ROAD HEIGHT IN RELATION TO EXISTING GROUND LEVEL ALONG LENGTH OF A14

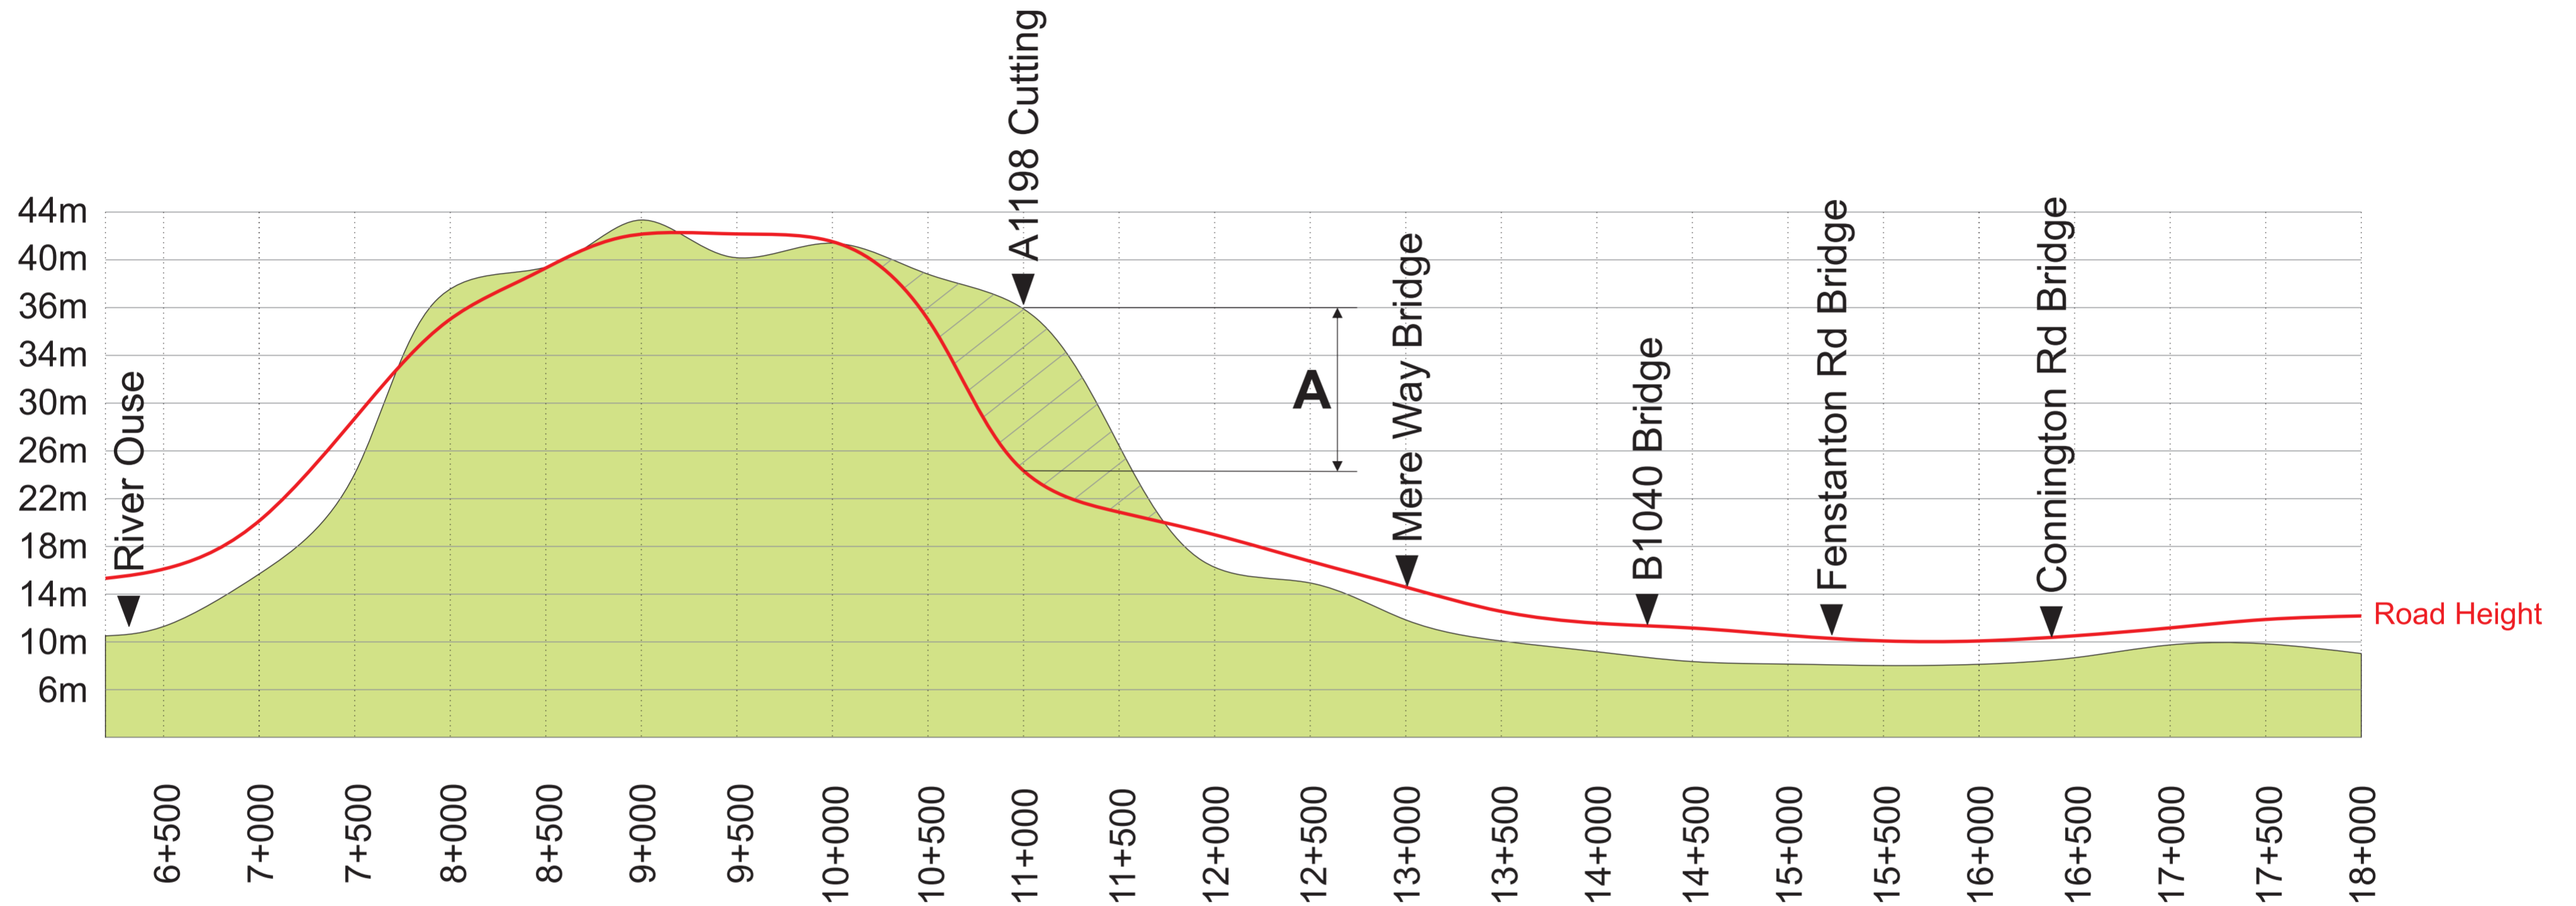
The proposed depth of the cutting 'A' and the height of the road above existing ground level is probably a result of a calculation to minimise the amount of material to be moved whilst providing adequate drainage for the new road.

If the cutting were to be deeper, the road could potentially be lower and there would be more spoil available for building bunds

BUT THIS WOULD BE MORE COSTLY.....HOWEVER **MUCH, MUCH** BETTER FOR HILTON AND SURROUNDING VILLAGES
